ADDENDUM #1

RE: Bid Item Changes & Plan Sheet Revisions

Contract ID: DN00294
County: Transylvania
Letting Date: April 9, 2019

LOCATION: BRIDGE No. 870162 ON SR 1361 (OLD NC HWY. 280)
OVER SILVER CREEK

GUARDRAIL SUMMARY

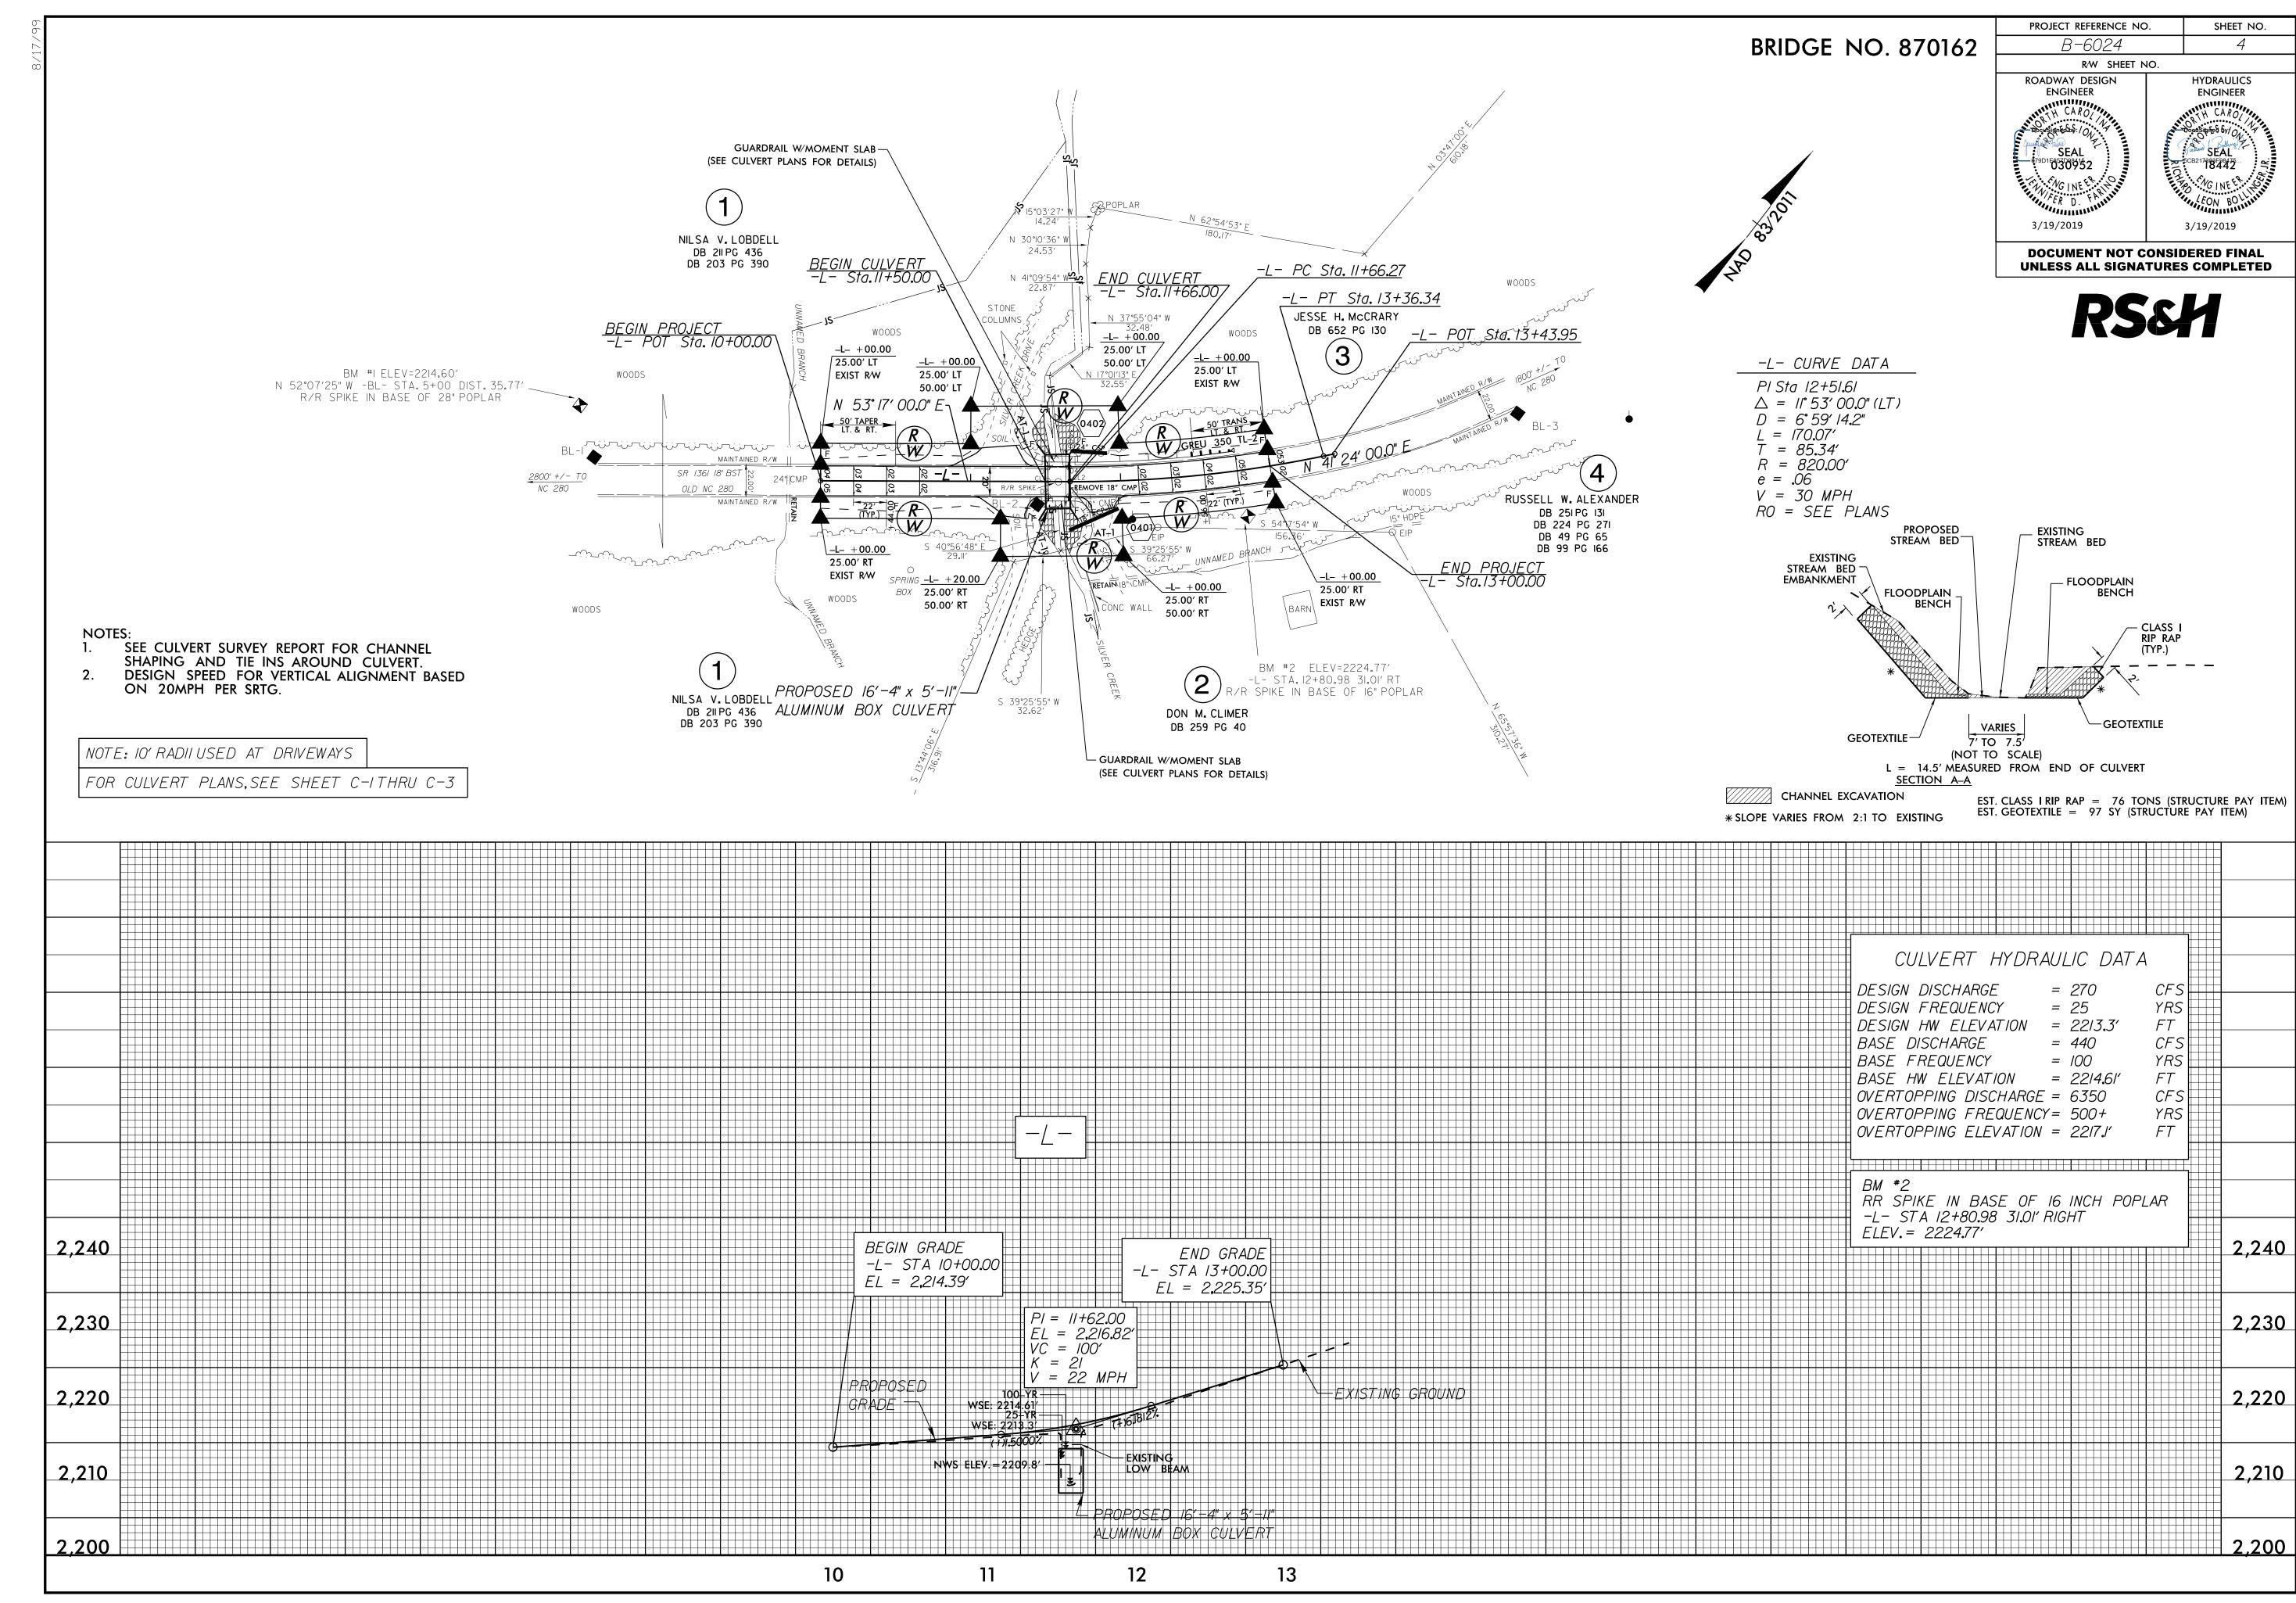
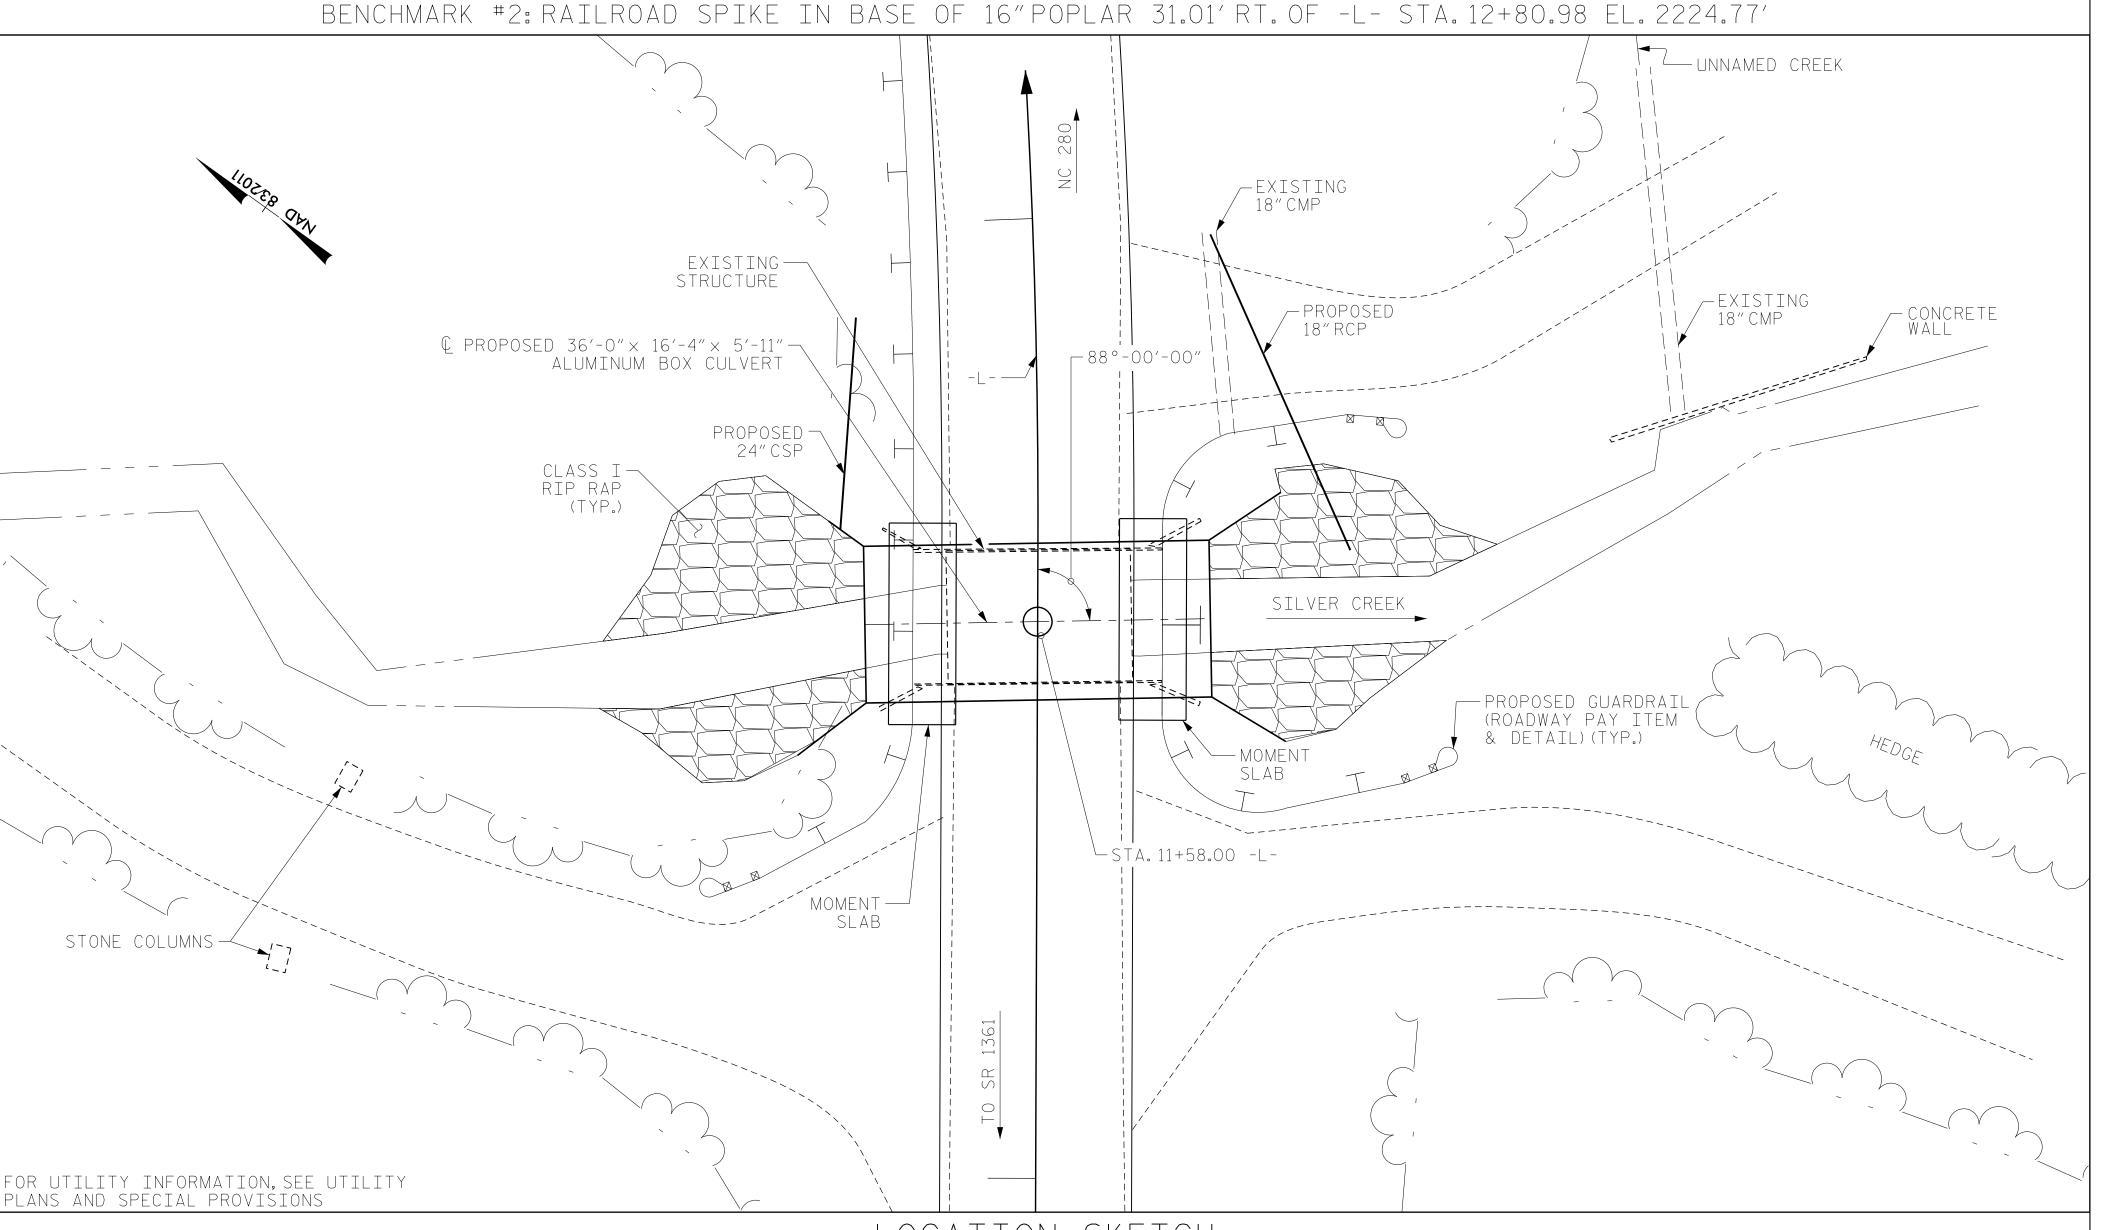
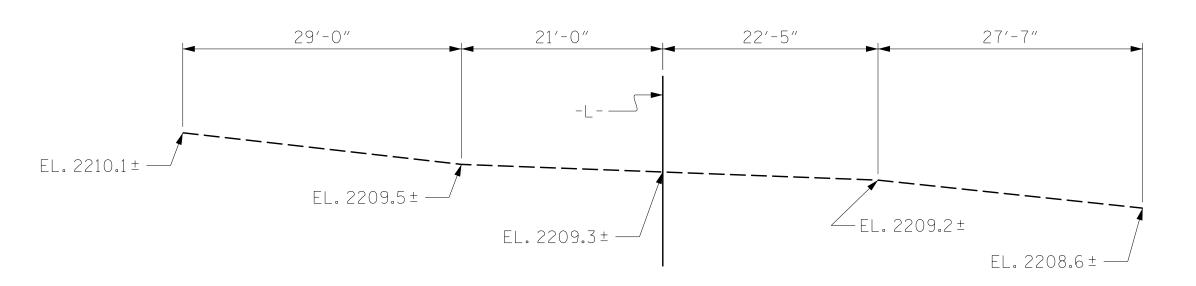
The 25' sections of clear span guardrail have been removed and replaced with a moment slab and anchored guardrail. Changes to the bid items and plan sheets have been made.

The quantities to the following items have been changed:
